PUD/POADP PLAN

JORGE GAMBOA
TOURNAT RD. & WURZBACH RD.
SITE PLAN
San Antonio, Texas

PRELIMINARY OVERALL AREA DEVELOPMENT PLAN APPLICATION (POADP)

Re: Mirage POADP # 643

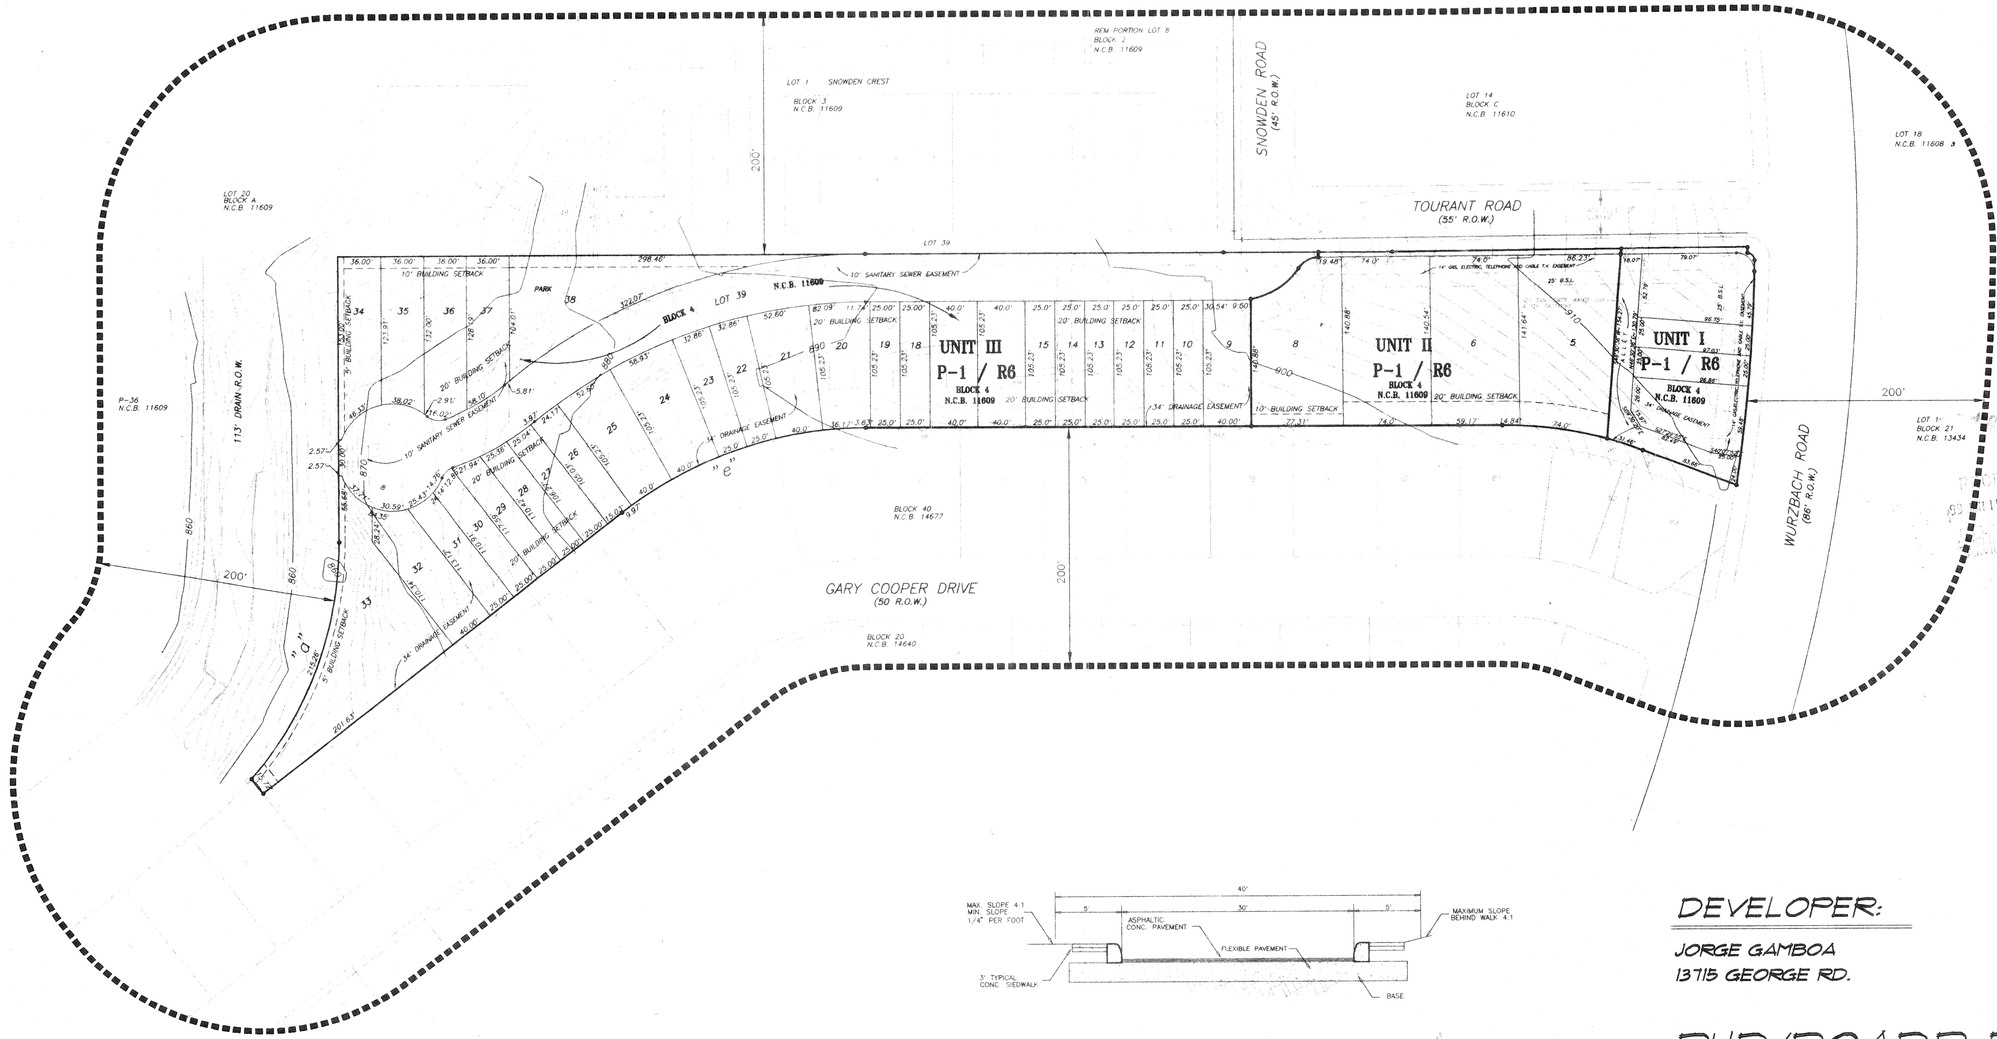
- Based on the topography, a Flood Plain Study and drainage review will probably be required during the platting process.
- In consideration of public safety and convenience, excessive grades by reason of topography should be avoided in street layouts and arrangements.

- Access and R.O.W. issues along State facilities will need to be resolved with the Texas Department of Transportation (TXDOT). For information about these requirements you can contact TXDOT at 615-5814.

- It will be expected that you will plat all of the property depicted in your POADP, to include: floodpains, drainage areas and open space.
- I would encourage you to work closely with the school district, so that they can plan accordingly.

- Since access to the lots fronting Wurzbach will be accessed by the alley, curb cuts will not be allowed along Wurzbach. Also, a one (1) foot non-access easement along Wurzbach must be shown on the plat.

- The geometry of the tie of the proposed Tourant Rd. to Snowden Rd. must be approved by Public Works at the time of platting.
